UNITED STATES PATENT AND TRADEMARK OFFICE

APPLICATION NO.	FILING DATE	FIRST NAMED INVENTOR	ATTORNEY DOCKET NO.	CONFIRMATION NO.
10/608,671	06/27/2003	Michael J. Pugia	017191.0033 (MSA-3452)	5201

Office Action Summary

DETAILED ACTION***Drawings***

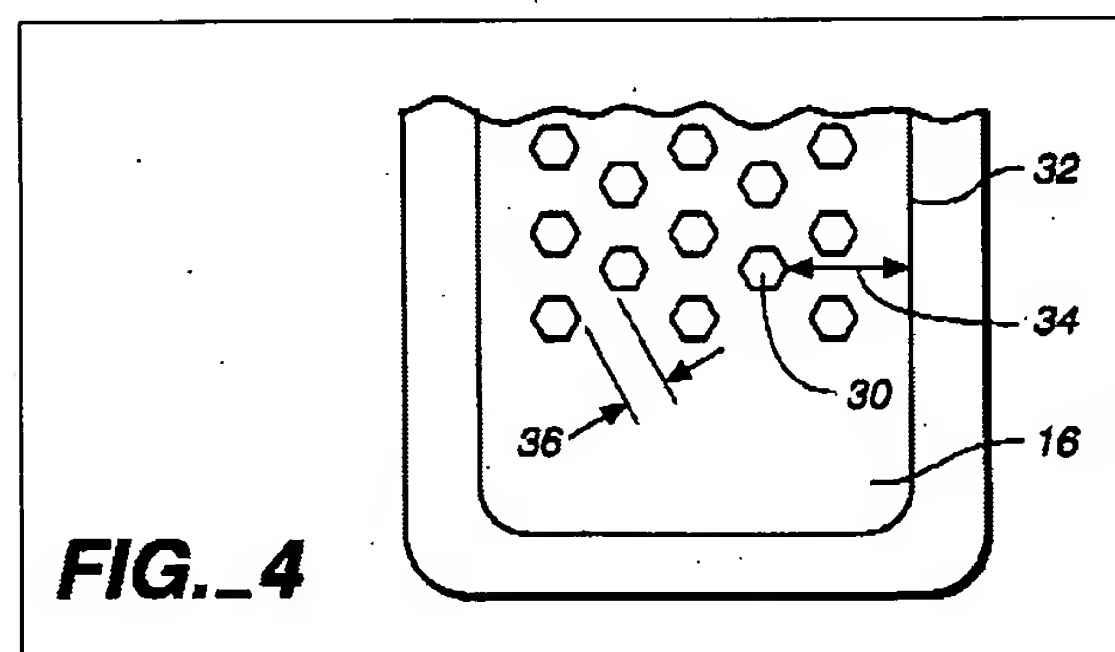
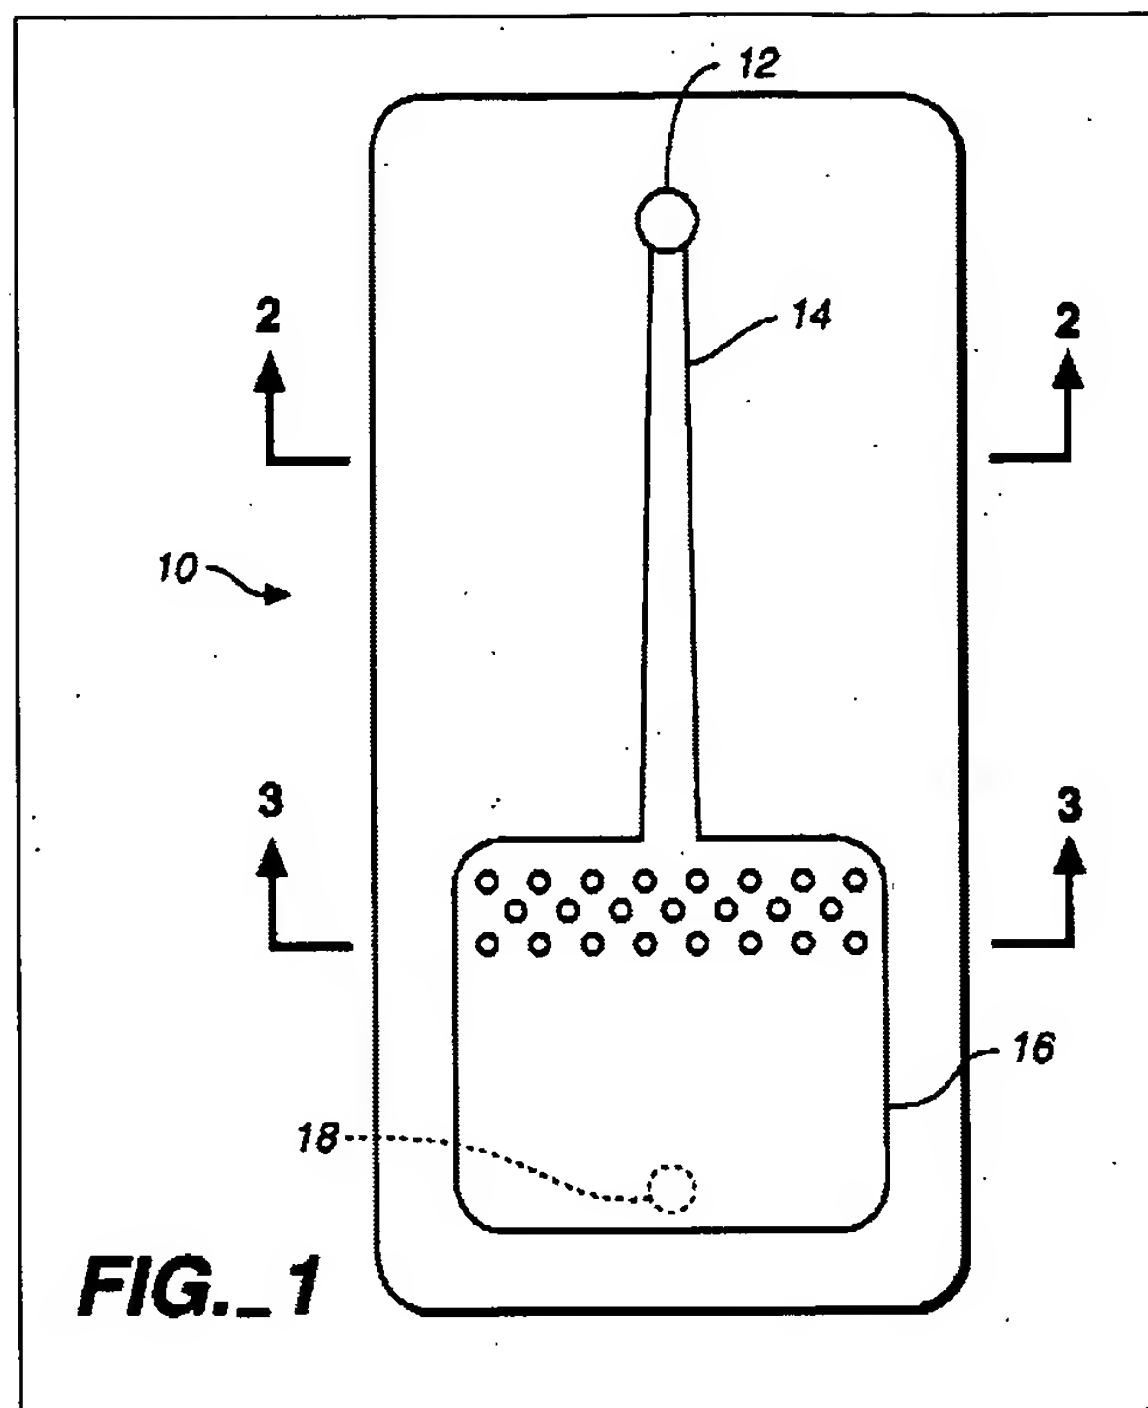
Claims 1 and 8 are rejected under 35 U.S.C. 102(b) as being anticipated by Buechler (U.S. Pat. No. 6,113,855 A).

Regarding claim 1, Buechler anticipates a microfluidic device comprising: an inlet port 12; an enclosed capillary passageway 14 in fluid communication with the inlet port 12; an enclosed inlet chamber (e.g., distal region 16) comprising an array of post structures (i.e., capillarity-inducing structures 30); and a vent structure (i.e., escape port 18) (see col. 5, line 21 – col. 7, line 43; figures 1 & 4). As shown in figure 1, the enclosed inlet chamber 16 is in fluid communication at one side or end side thereof with the enclosed capillary passageway 14. In addition, as shown in figure 1, the vent passageway 18 is positioned at a top side of the enclosed inlet chamber opposite the entry of the capillary passageway 14 into the enclosed inlet chamber 16.

Regarding claim 8, Buechler anticipates that the inlet chamber 16 containing the assay volume comprises a reagent (e.g., surface bound reactants comprising solid phase bound antibodies which react with sample antigen) (see, e.g., col. 4, lines 42 – 67; col. 5, line 54 – col. 6, line 5). Claim 8 does not specifically recite that the reagents are covalently bound or immobilized within the inlet chamber. This claim does not exclude the interpretation that fluid reagents can be utilized with the disclosed device.

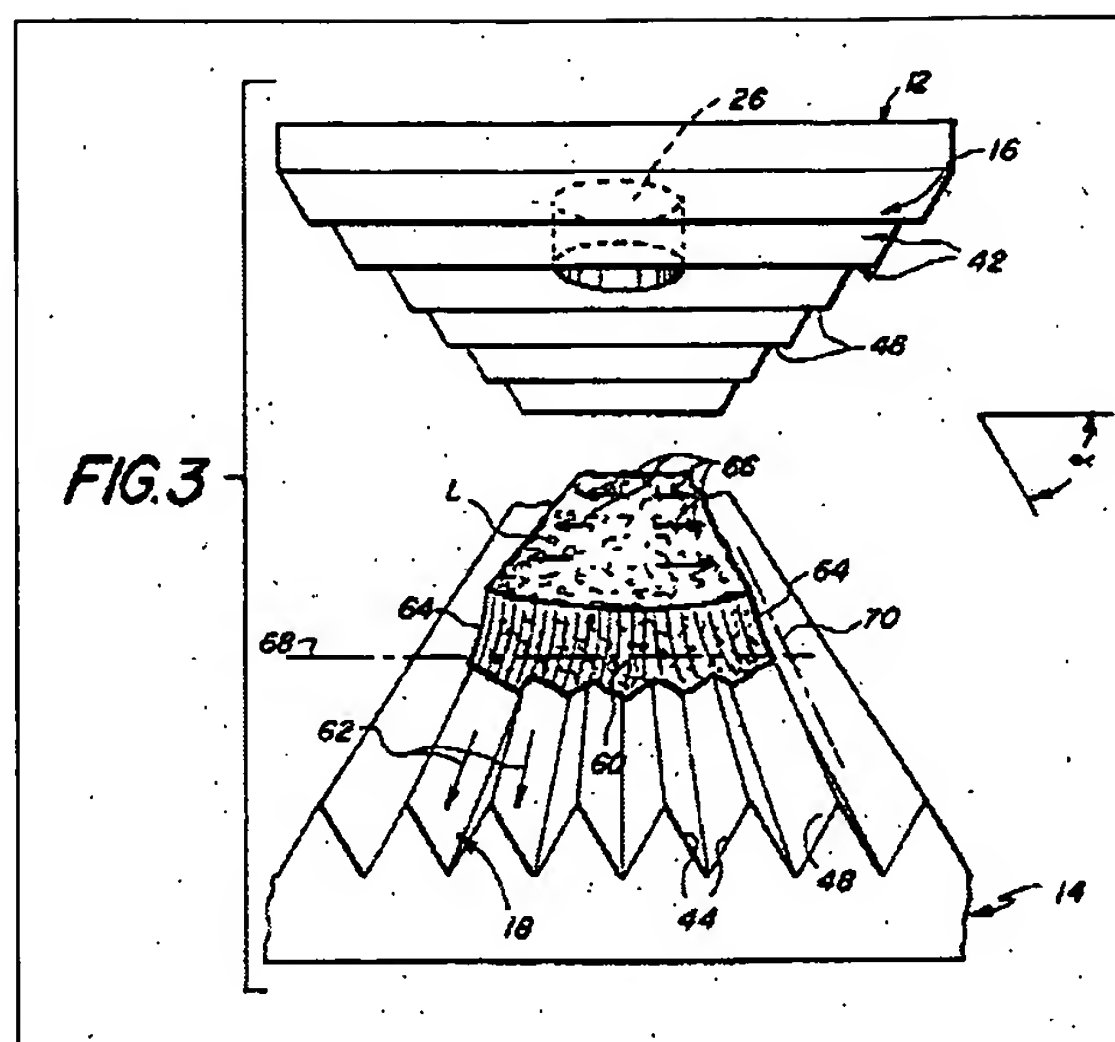
1. Claims 2 and 3 are rejected under 35 U.S.C. 103(a) as being unpatentable over Beuchler in view of Columbus (U.S. Pat. No. 4,233,029).

Regarding claim 2, Beuchler does not specifically teach the incorporation of at least one groove structure extending across the inlet chamber 16.

Columbus teaches the use of groove structures (e.g., 42 & 44) for facilitating uniform fluid flow within microfluidic devices (see, e.g., col. 5, lines 1 – 55; figure 3).

Hence, as shown by Columbus, a person of ordinary skill in the art would accordingly have had a reasonable expectation for success in incorporating the use of a groove structure with an analytical microfluidic device for facilitating uniform sample fluid introduction into the device for processing and analysis (see MPEP § 2143.02). Therefore, it would have been obvious to a person of ordinary skill in the art to incorporate a groove structure as claimed with the disclosed microfluidic device.

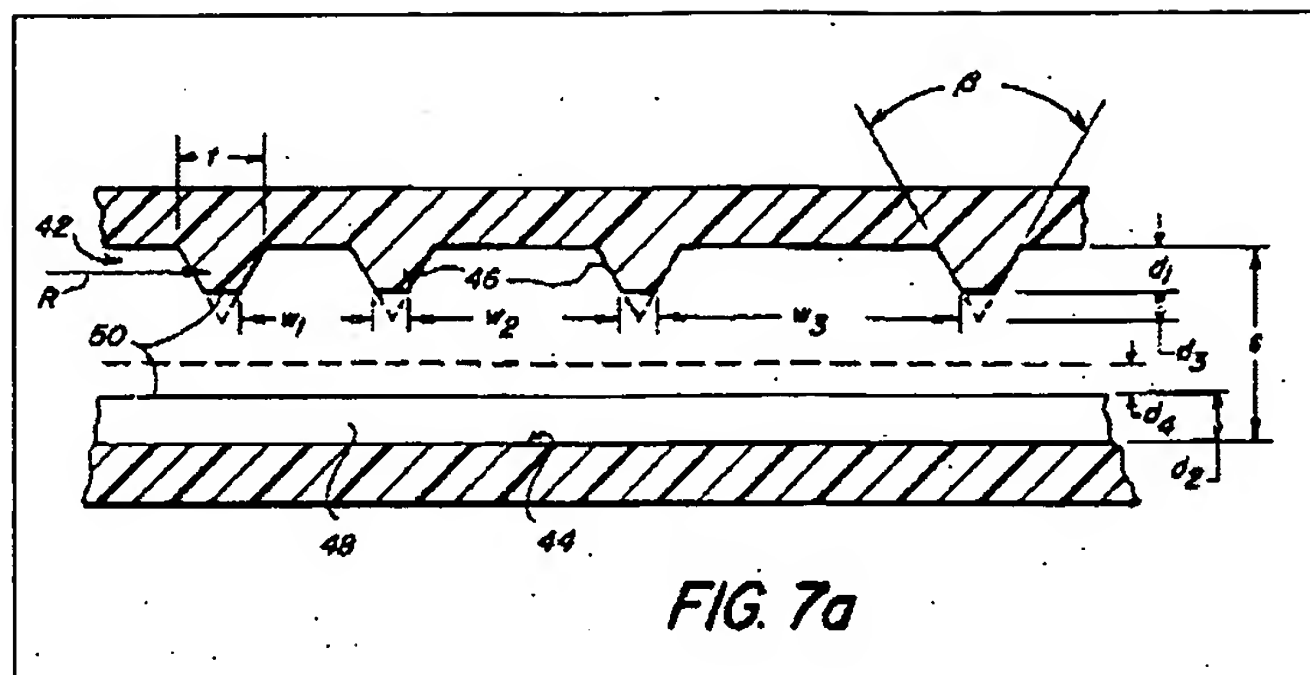
Regarding claim 3, as shown in figure 7a, Columbus further teaches the incorporation of weir structures (e.g., truncated ridges 46) within the device (see, e.g., col. 8, lines 1 – 51). Therefore, it would have been obvious to a person of ordinary skill in the art to incorporate a weir structure as claimed for facilitating effective sample fluid flow with the disclosed microfluidic device.

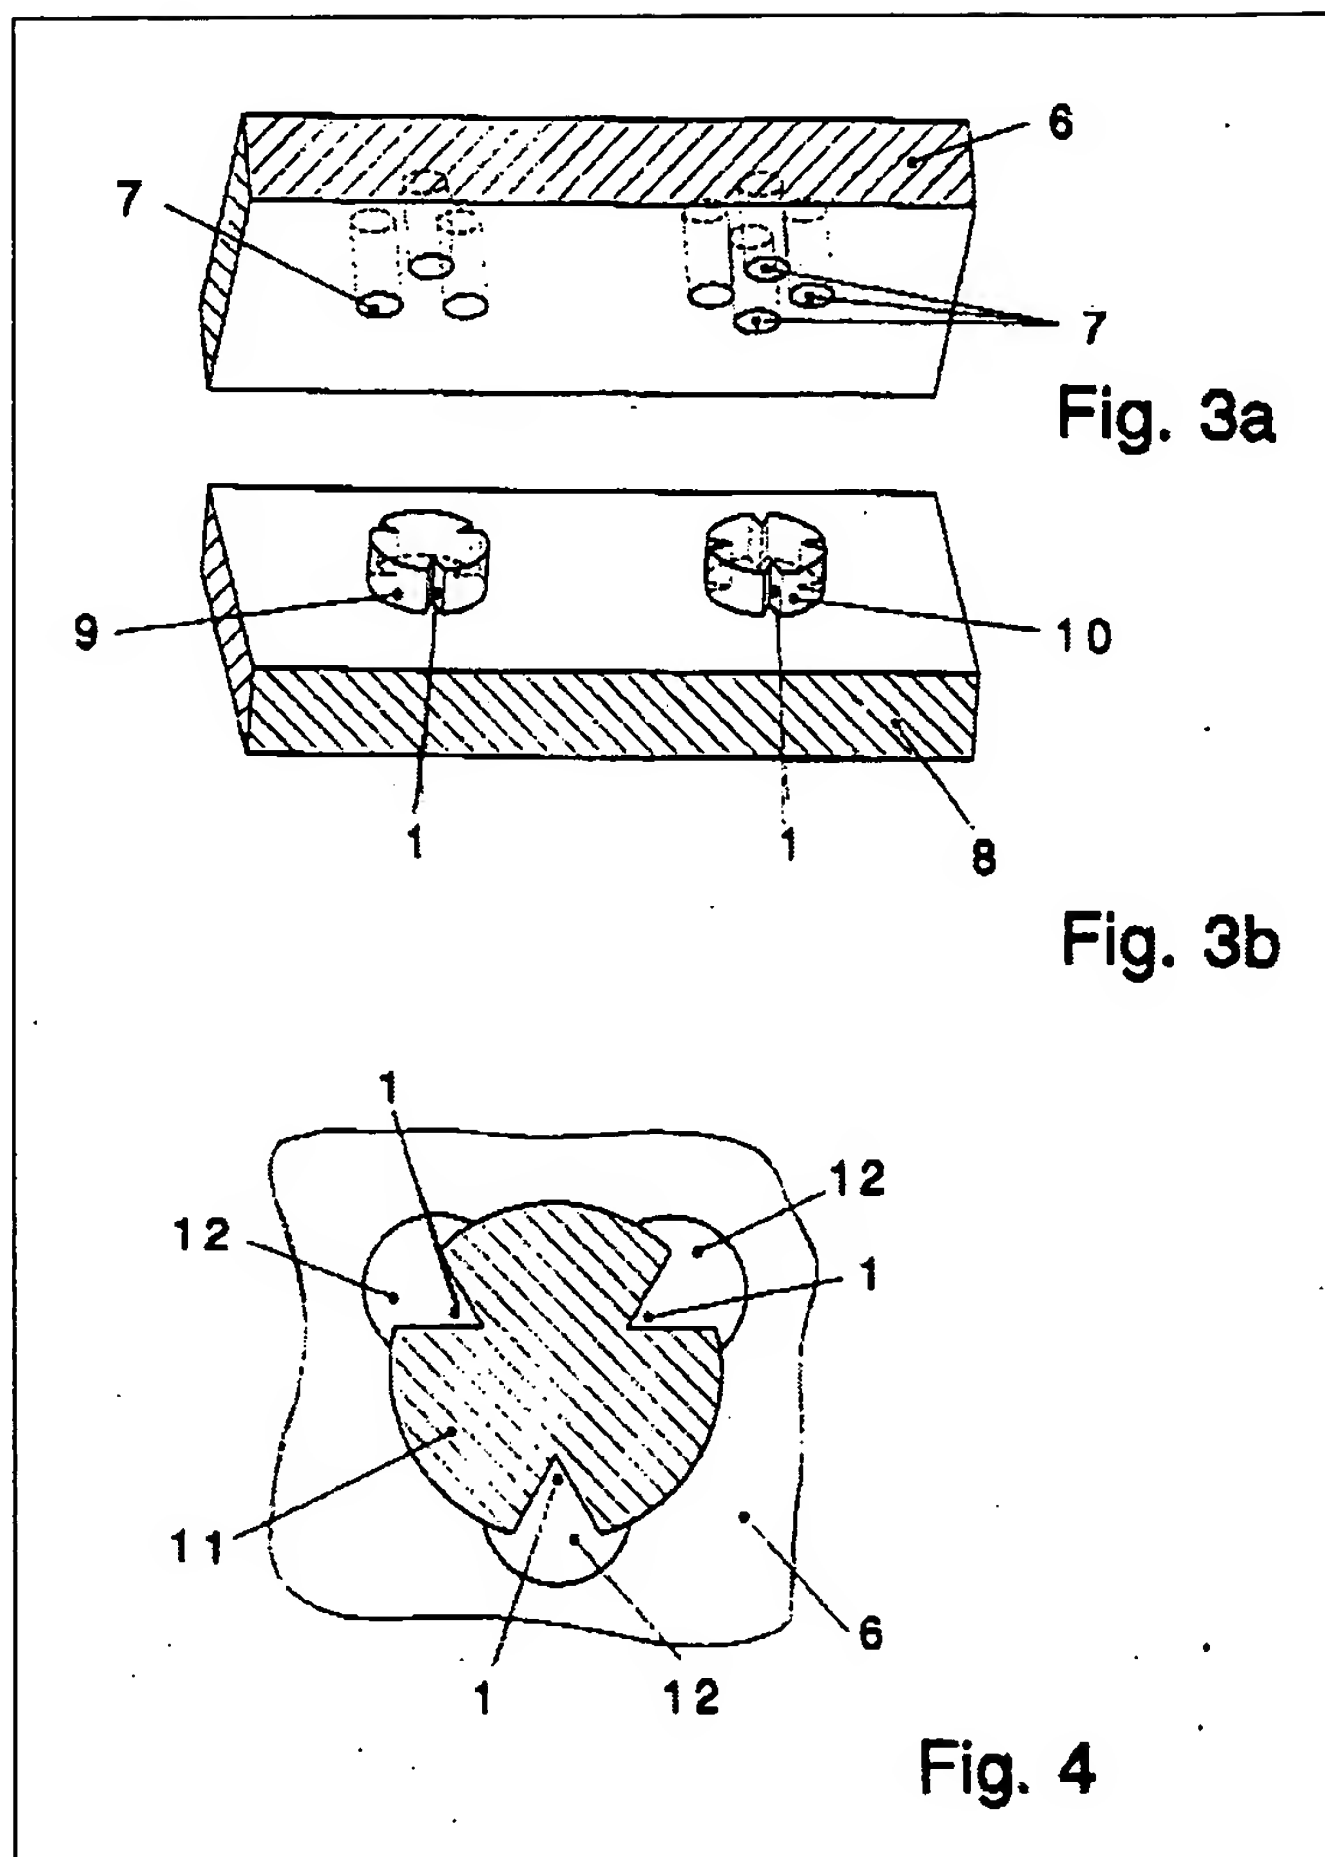
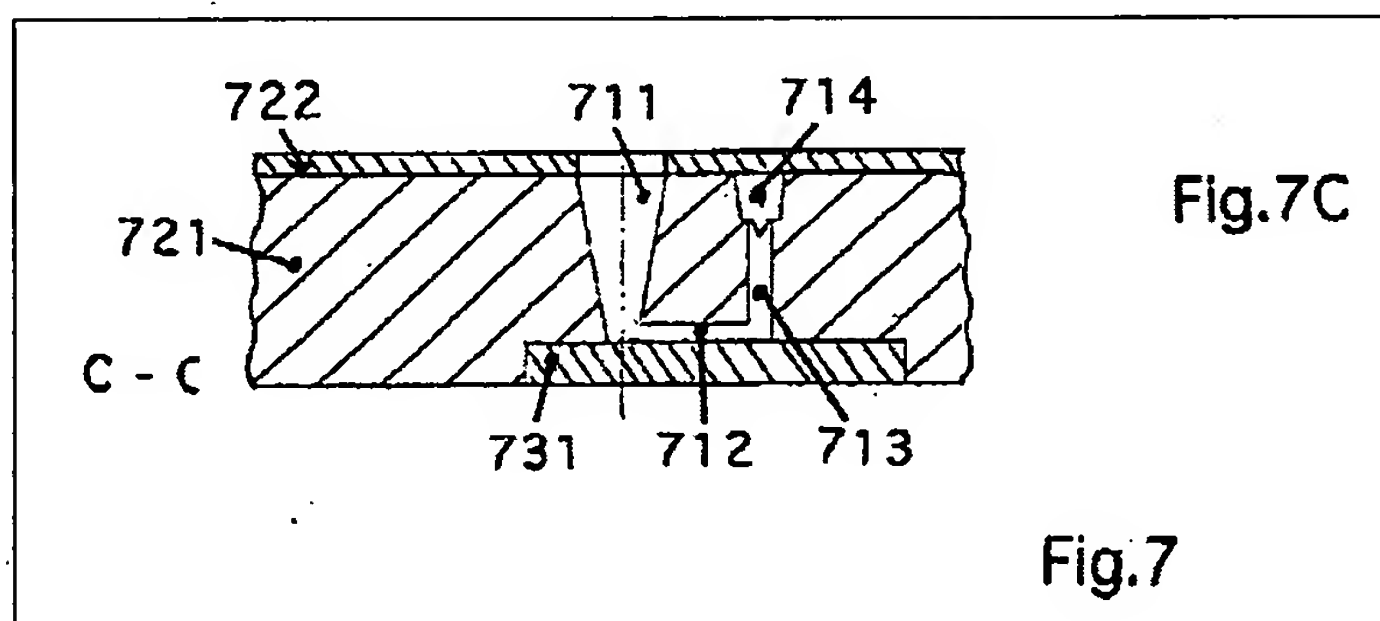
Regarding claims 4 and 6, Buechler and Columbus are silent to the specific teaching of incorporating wedge-shaped cut-out structures with either a groove or weir structure within the disclosed microfluidic device. As shown in figure 3b, Peters does teach the incorporation of wedge-shaped cut-out structures (post or columnar projection 9 having wedge-shaped cut-outs 1) within a microfluidic apparatus for facilitating effective fluid control within a microfluidic device (see col. 1, line 10 – col. 6, line 67; figures 1a, 3b & 4).

As evidenced by Peters, a person of ordinary skill in the art would have recognized the suitability of incorporating the use of wedge-shaped cut-out structures within a microfluidic apparatus for the intended purpose of facilitating effective fluid control (see MPEP § 2144.07). Consequently, a person of ordinary skill in the art would accordingly have had a reasonable expectation of success of incorporating the use of these wedge-shaped cut-out structures within a microfluidic apparatus for facilitating effective fluid control (see MPEP § 2143.02). Therefore, it would have been obvious to a person of ordinary skill in the art to incorporate the use of

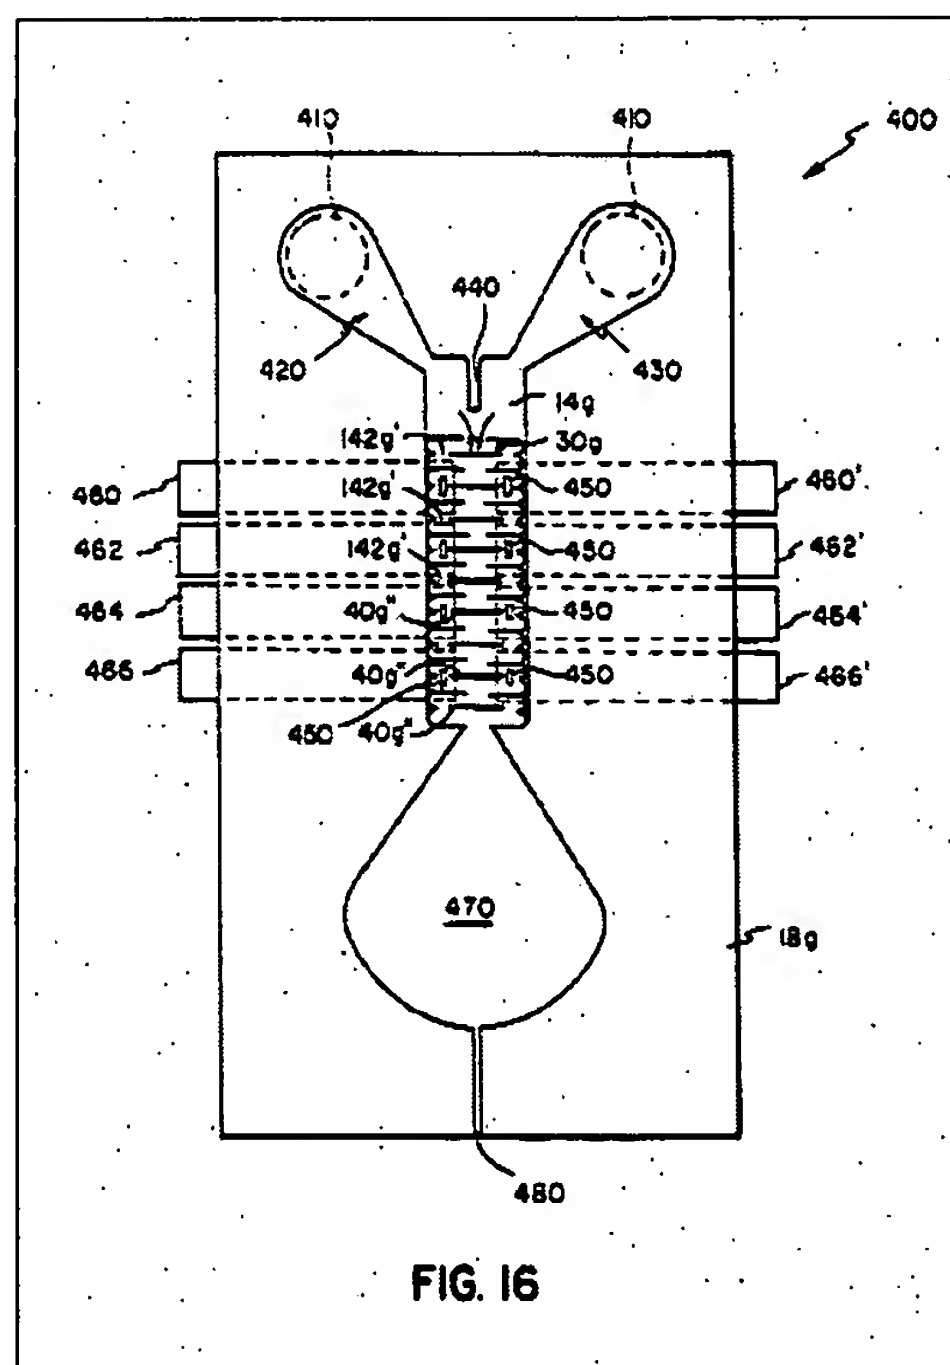
Columbus '476 teaches the incorporation of an overflow chamber 470 within a microfluidic device to facilitate effective sample fluid introduction and subsequent processing (see figure 16). Therefore, it would have been obvious to a person of ordinary skill in the art to incorporate an overflow chamber within the disclosed microfluidic device to facilitate effective sample fluid introduction and subsequent processing.
